Zoning Staff Report

Case Number: ZC-21-181

Hughes' House

Hughes House - Overall Site
ROSEDALE AND AMANDA
FORT WORTH, TX

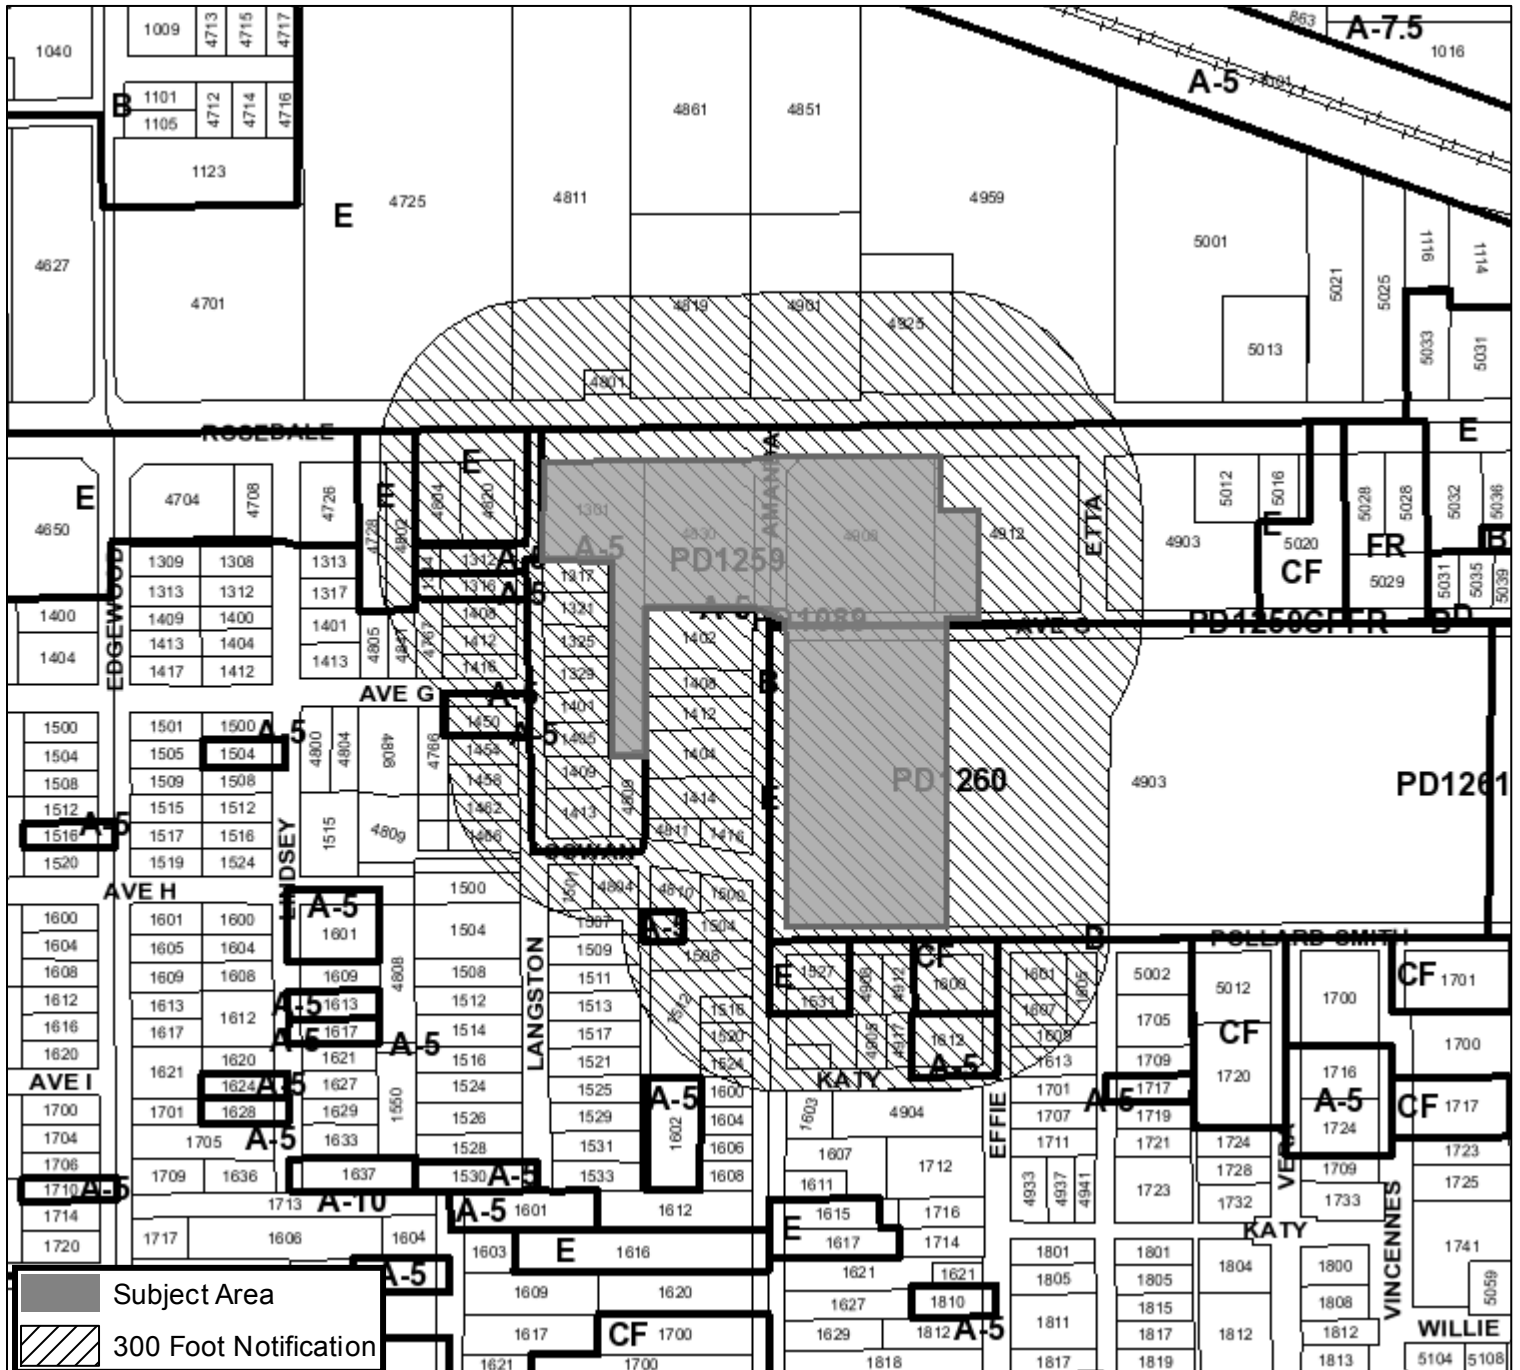
- The two references in the “General Notes” section to the Urban Forestry and Landscaping section have been redlined by staff to show the correct wording and section references for the PDs based on MU-1 and UR; the references provided on the site plan are not applicable to the MU-1 and UR zonings of the PD, but rather apply to the normal base zonings.

- The maintenance building located along the A-5 property near Building 1 is not allowed where it is shown. Because of the adjacency to A-5, that area is subject to a 5’ bufferyard and 20’ supplemental setback. No buildings can be placed within the 20’ supplemental setback. In the 2019 PD case, a waiver from the bufferyard requirement was requested but it was not approved; therefore the project must comply with the bufferyard and supplemental setback requirements of the Ordinance. This maintenance building must either be moved out of the 20’ supplemental setback, or an additional development standard must be requested of the Urban Design Commission, then Zoning Commission, then City Council, in order to allow the building to exist within the required 20’ supplemental setback. Staff has written into the motion recommendation that this maintenance building should be moved out of the 20’ supplemental setback.

- The requested setback increase as presented at UDC was for the PD/MU-1 portion of the site. No setback increase was included for the PD/UR portion of the site. Staff has measured the setbacks of the buildings to the streets in the UR portion of the site; it appears that Building 8 is placed further than the maximum 20’ setback from Calumet Street. The building should be shifted forward a few feet so that the front build wall is within the maximum 20’ setback from the street. It appears, to the best

of staff's judgement, that the remaining buildings in the UR portion of the site plan do not exceed the 20' setback; however, if any other buildings exceed the 20' setback, they also should be pulled forward to be within the 20' maximum setback from the street. Staff has written into the motion recommendation that Building 8 be moved forward to meet the maximum 20' setback from the street.

Staff Recommendation: **Approval, pending the below two changes:**
1. The maintenance building be moved out of the 20-foot required supplemental setback
2. Building 8 be moved forward so the front build wall is within the 20-foot maximum setback from Calumet Street

Zoning Commission Recommendation: **Approval as Amended to include the two site plan changes recommended by staff and listed above.**
